# **Central Planning Authority**

**Minutes of a meeting of the Central Planning Authority held on August 3, 2022 at 10:00am in Conference Room 1038, 1st Floor, Government Administration Building, and Elgin Avenue.**

**CPA/19/22**

**Figure 1: 2018 aerial imagery showing the development (seawall line shown in orange) in relation to the historical (established) vegetation line (Source: LIS 2018).**

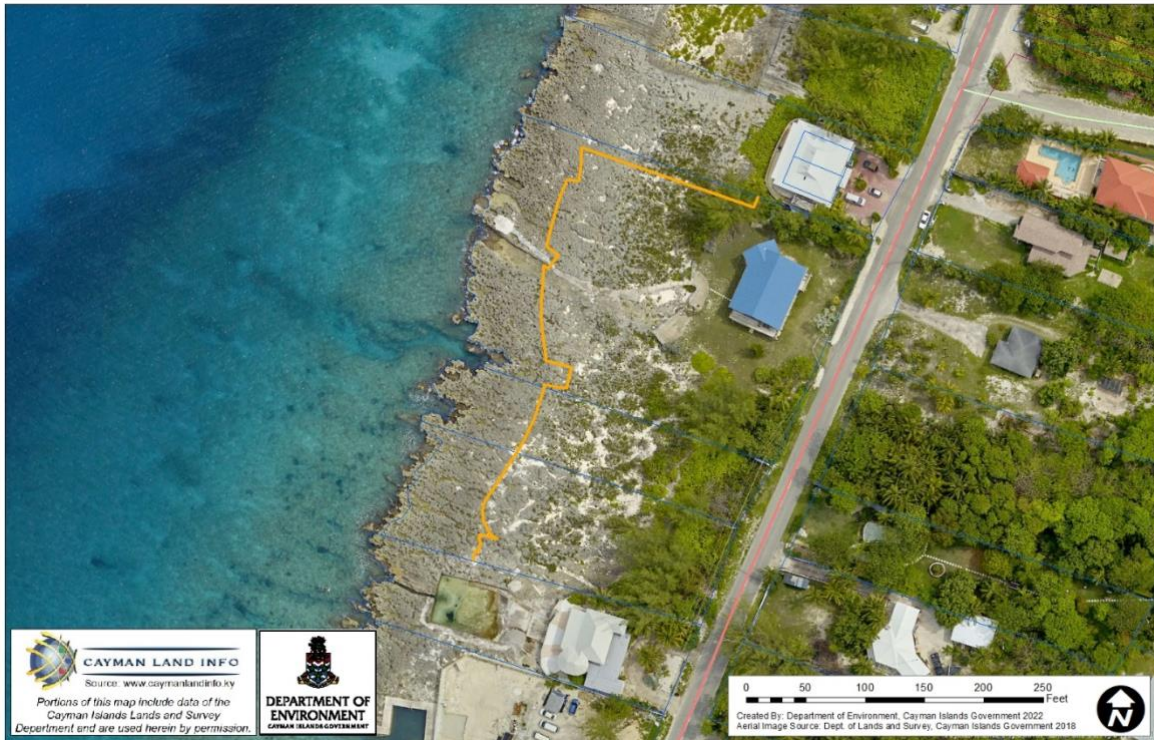
*Whilst the application has met the 50-foot coastal setback required in the Development and Planning Regulations, we note that the proposed development would be located closer seaward than that of the neighbouring developments. The subject parcel's coastline highlights the need for site-specific consideration of setbacks instead of an overall "blanket" setback approach for the generalised categories of beaches, ironshore or mangrove coastlines. Coastal setback recommendations should also be informed by other factors such as the off-shore marine environment, historical erosion rates or extreme water levels, rather than adopting arbitrary distances that are not representative of erosion and coastal flooding threats. Given the climate change predictions for the region, including sea-level rise and increased intensity of storm events (including storm surge) the DoE recommends that the applicant positions their development as far landward as possible. The applicant may also wish to incorporate climate resiliency features such as elevated structures or a wash-through ground floor.*

*The natural/permanent vegetation line of the subject parcel is a good indicator of the energy of the coastline and the incursion of the sea on a regular basis. Figure 1 shows the historical vegetation on-site in 2018 and the proposed building setback line in orange; development that is situated seaward of the approximate historical vegetation line increases its vulnerability to flooding and storm damage.*

- *Revises plans to position the development as far landward as possible and/or incorporates climate-resilient features such as raised/wash-through foundations in order to increase the development's resiliency to storm impacts and climate change.*
- *Plants and incorporates native vegetation into the landscaping scheme for the development. Native vegetation is best suited for the habitat conditions of the Cayman Islands, requiring less maintenance and less supplemental irrigation, meaning once it is established, landscaping with native vegetation is a very sustainable and cost-effective*

Figure 1: An extract of the DOE's 2013 Habitat Map showing the application site outlined in red.

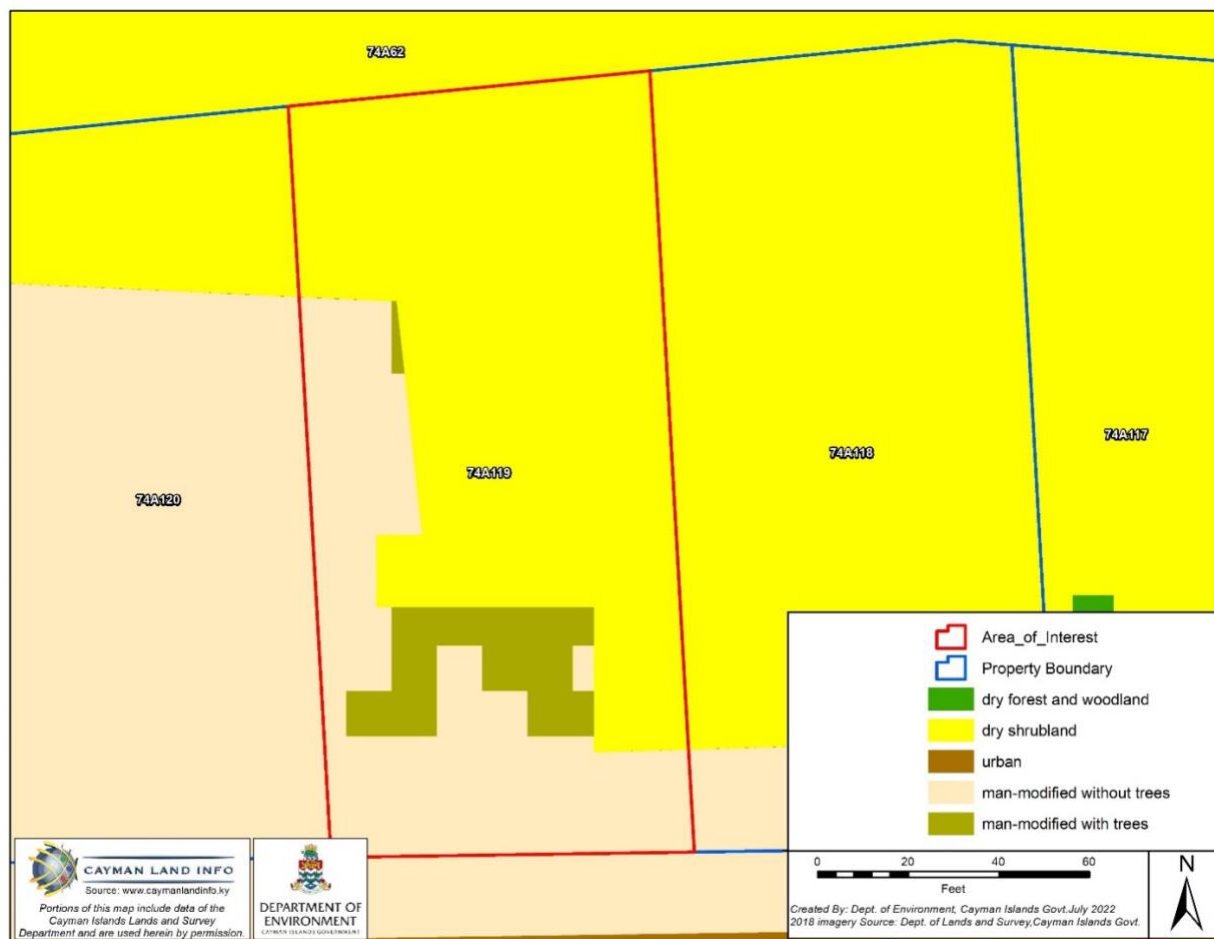
*The application site predominately primary dry shrubland habitat and secondary growth as shown in Figures 1 and 2. These habitats are of high ecological value and provide a biodiverse habitat for native wildlife including Grand Cayman Blue Iguanas (*Cyclura lewisi*). There are some man-modified areas to the south and along the boundary with the property to the west.*

*Figure 3: LIS 2018 Aerial image showing the subject parcel in relation to the Colliers Wilderness Reserve.*

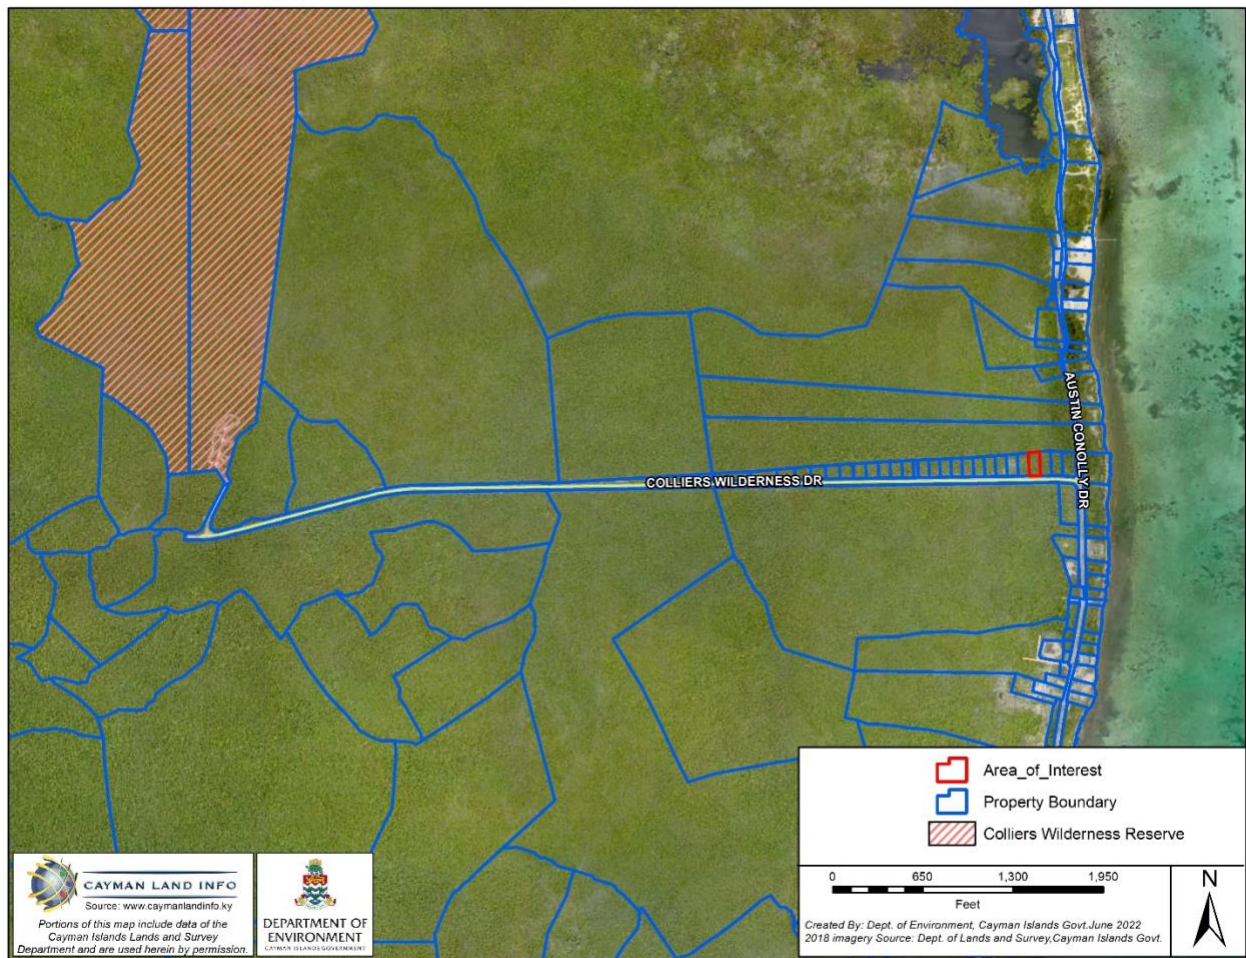
*Habitat loss and fragmentation are one of the largest threats to our wildlife. Our native species have complex daily requirements that require them to travel safely from place to place, looking for nesting sites, food, water, a resting haven and shelter. With the increased urbanisation of the island, habitats become fragmented and separated from each other, and wildlife corridors are vital for the survival of our species. They bridge the gap between smaller, isolated habitats. Linking core wildlife habitats helps to restore and preserve biodiversity, allowing movement between important habitats to maintain genetic diversity in wildlife populations. Without this, local extinctions can occur.*
